. CITY OF SACRAMENTO .
. DESIGN REVIEW - PRESERVATION BOARD .

LOCATION: **2022 4th Street and 2024 4th Street**
Council District 4

PROPOSAL: The applicant proposes construction of two duplex structures on abutting parcels in the South Side Preservation Area. One will be at 2022-4th St., and the other at 2024-4th St.---total of four units. The buildings will be similar to the one at 2011-4th St.

PB95-033

SITE PLAN
SCALE: 1/8" = 1'-0"

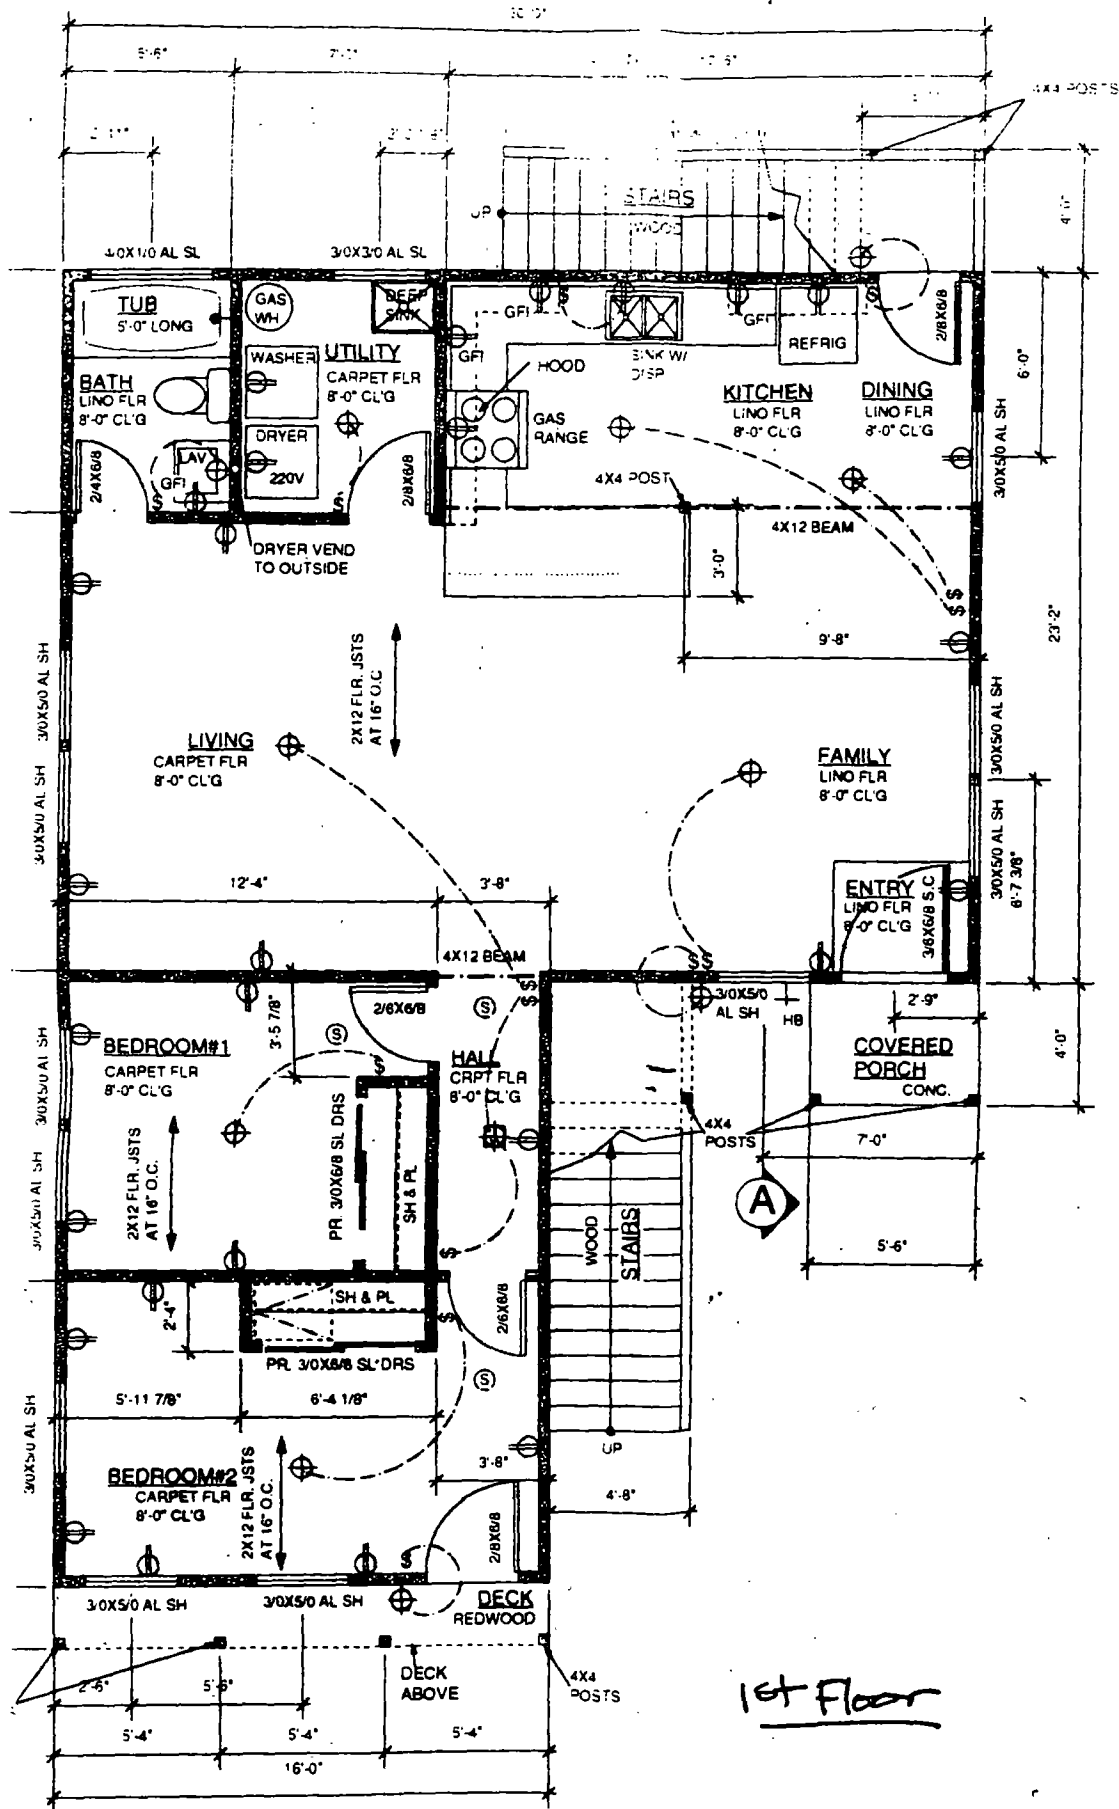
1. In other Central City duplex projects, and consistent Design Review Guidelines Section IV-B-2, the Board has sought to locate parking at the rear of the sites. There are 2 onsite

parking spaces required for each parcel. The applicant's submitted plans locate the 4 spaces in the front yard setback of the parcels. The width of the buildings as designed would preclude driveway access to the rear yards.

Due to the time delay that would result, the applicant is reluctant to redesign the project with the parking in the back. Section 6-D-18 of the Zoning Ordinance indicates that the Planning Commission may issue a special permit to waive parking for 40' x 80' interior lots in the Central City. While the applicant is not adverse to not providing on-site parking, he is anxious to begin construction of the duplexes and does not wish to apply to the planning Commission for this permit because of the time and costs involved.

1. The applicant shall redesign the project to locate the required parking spaces to the rear of the duplex structures. If, in the future, the applicant obtains a parking waiver from the City Planning Commission, the applicant does not need to redesign the project to locate those parking spaces in the rear. Under no circumstances shall parking spaces be permitted in the front yard setbacks of the two lots. This condition includes required spaces as well as additional parking spaces.

FRONT ELEVATION

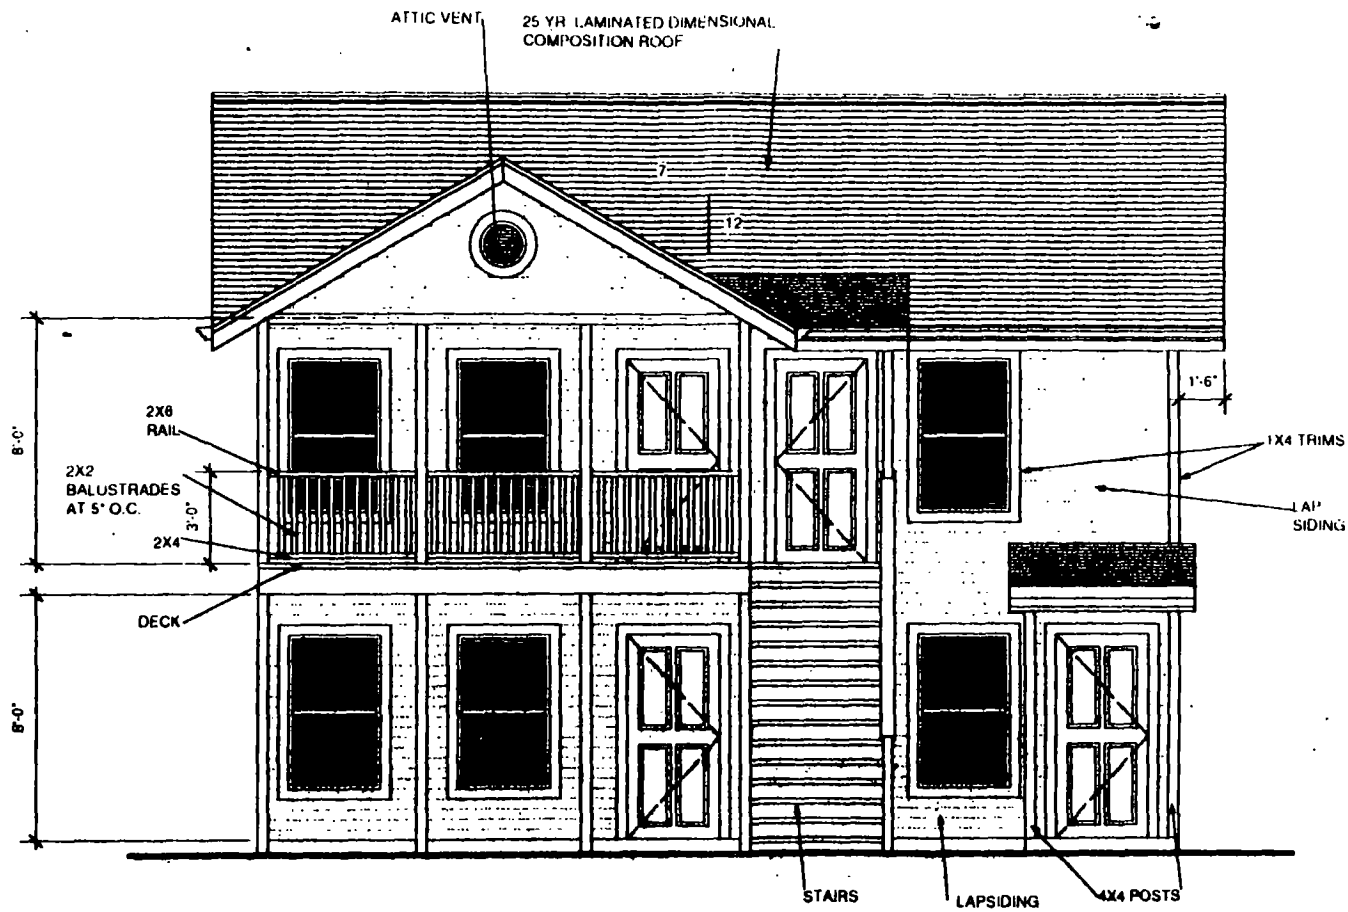
Staff would prefer an inexpensive wood unit over metal. Also, the single-hung units should be included on the rear elevation.
 - b. A covered front porch and balcony have been incorporated into the design. The applicant has eliminated two feet from the front of original floor plan in order to accommodate both the porch and balcony requirement and the staff alternative plan for the parking within the front setback area.

The narrow two foot depth of the front porch and balcony physically limits their usefulness and visually results in a somewhat cramped appearance, particularly with respect to the balcony. This problem would not exist and the loss of square footage from the interior space would not be necessary if it were not for the parking being in the front setback area.

6. An additional consideration, not previously suggested to the applicant, is to expand the landing at the 2nd floor entry as a balcony across the facade to the corner of the building. There is no such balcony on the existing building. However, a balcony would be an additional design enhancement on the new buildings.
